**PLANNING BOARD
PORTSMOUTH, NEW HAMPSHIRE**

MARCH 18, 2021

AGENDA

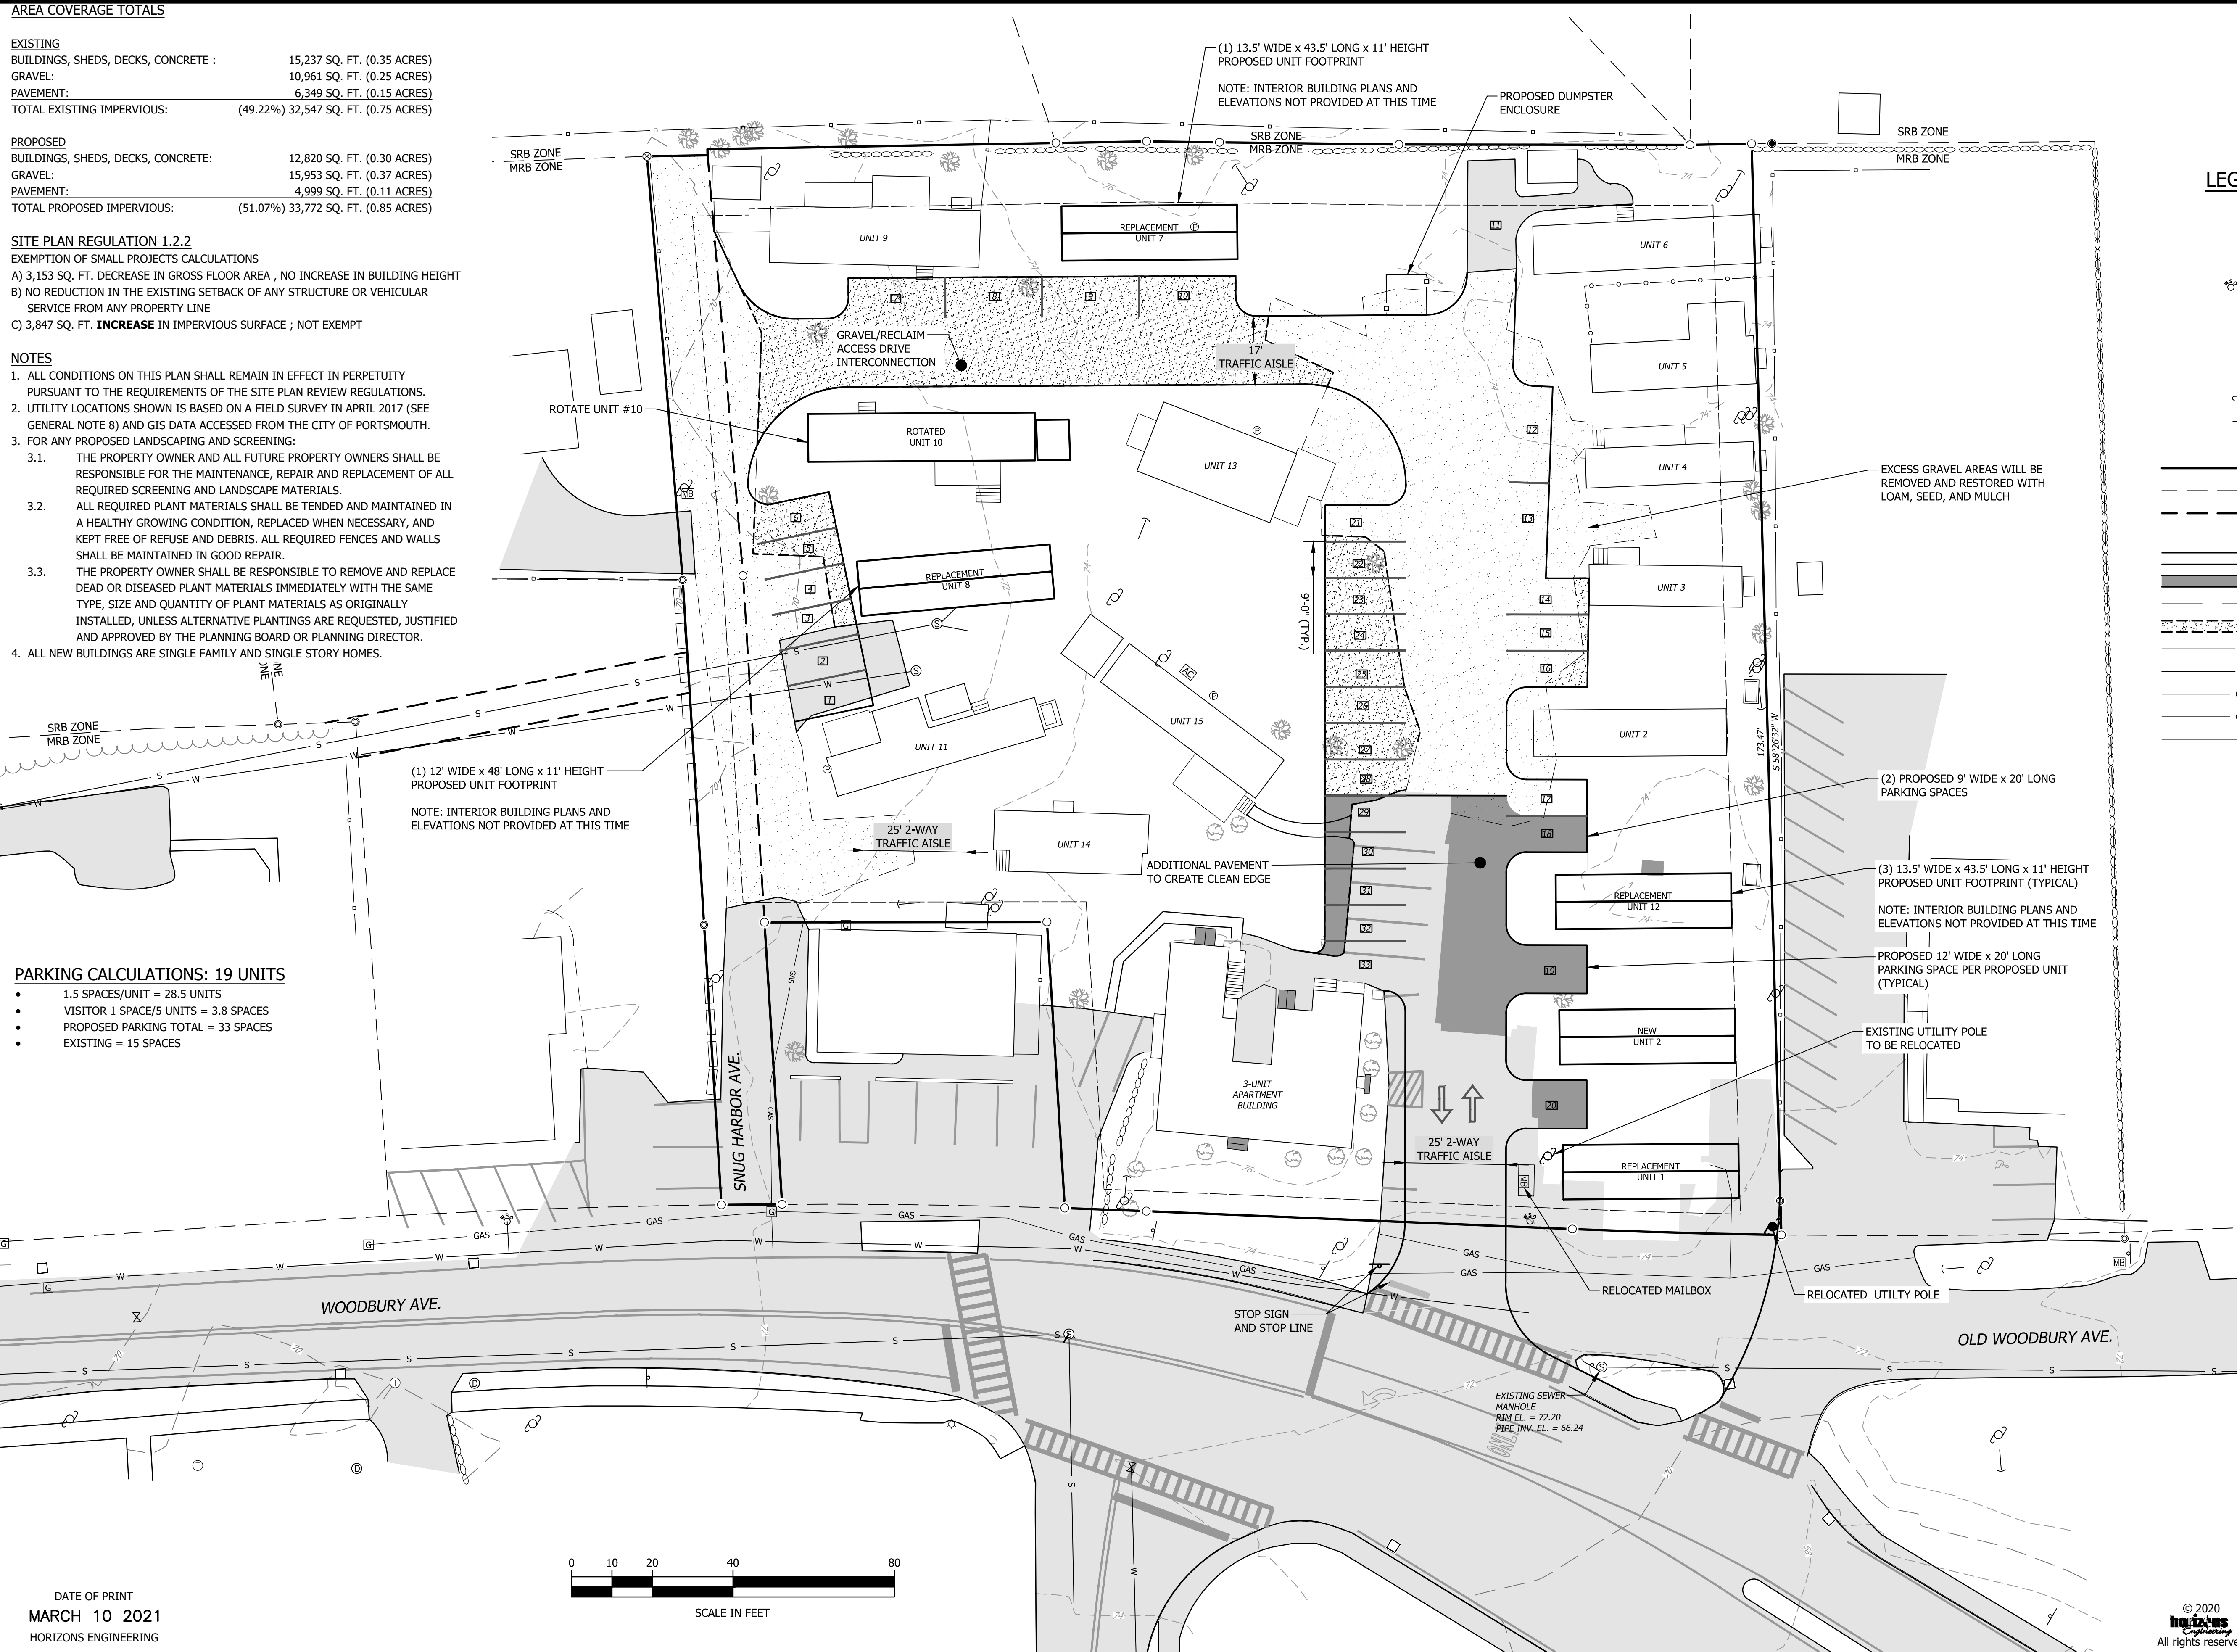
We agree with this comment. The changes have been made to the site plan (Sheet 3).

We agree with this comment. The changes have been made to the site plan (Sheet 3) and a detail has been added to Sheet 8.

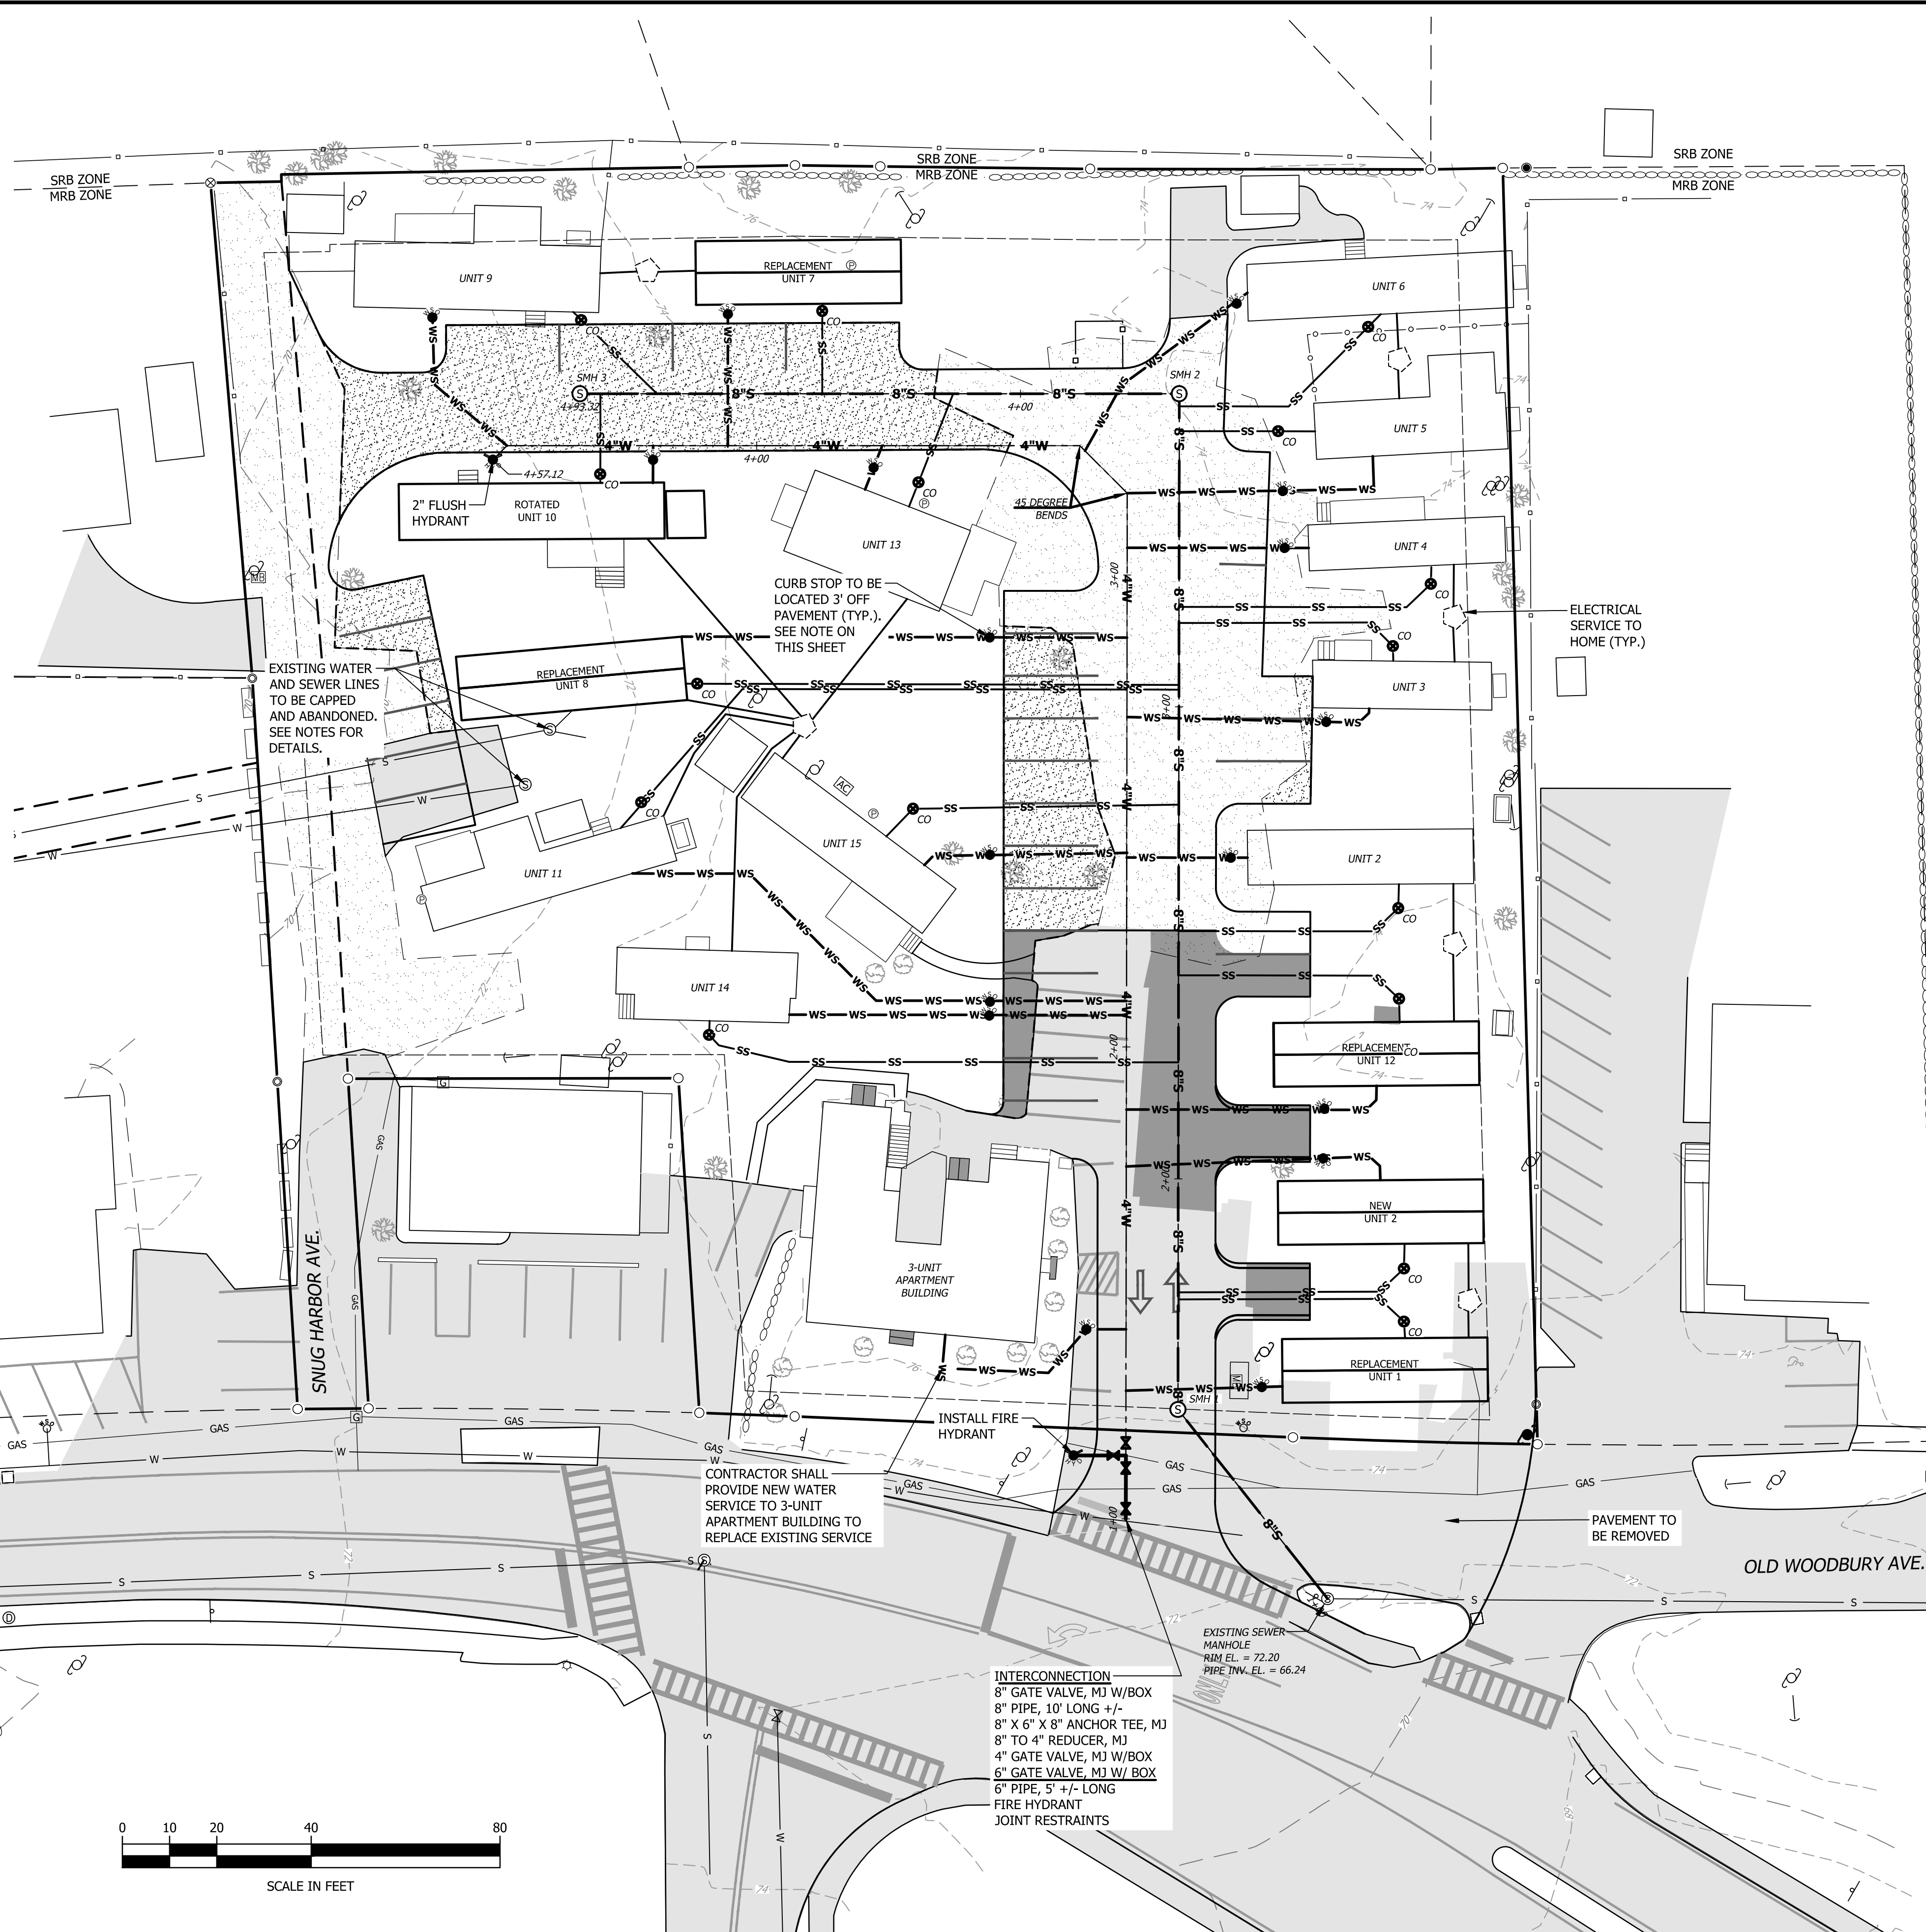
Notation has been added to the plans on Sheet 4 Water and Sewer Construction Notes 10 and 11.

Notation has been added to the plans on Sheet 4 Water and Sewer Construction Note 12.

This has been corrected. Both shut offs are shown on Sheet 4.

This change has been made to Sheet 4.
